THE CITY OF WICHITA

OFFICE OF ENGINEERING

SUBJECT DRAINAGE PLAN: OVERBROOK 2ND  
ADDITION

OVERBROOK 2ND ADDN.  
REVERSED GRADING PLAN

OVERBROOK ZND  
 DRAINAGE THRU RESERVE A  
 $Q_{100} = 344 \text{ cfs}$

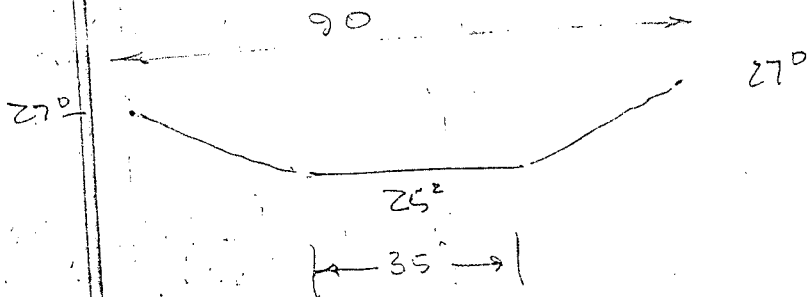
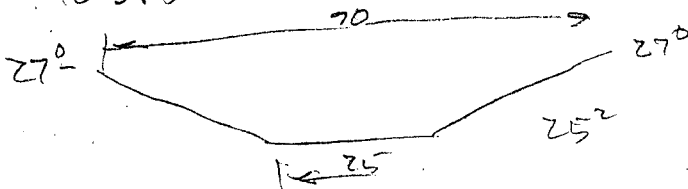
CHANGE EXIST X-SEC.

Try 25 BOT.

X-SEC OK  
 W.C. 1327.0
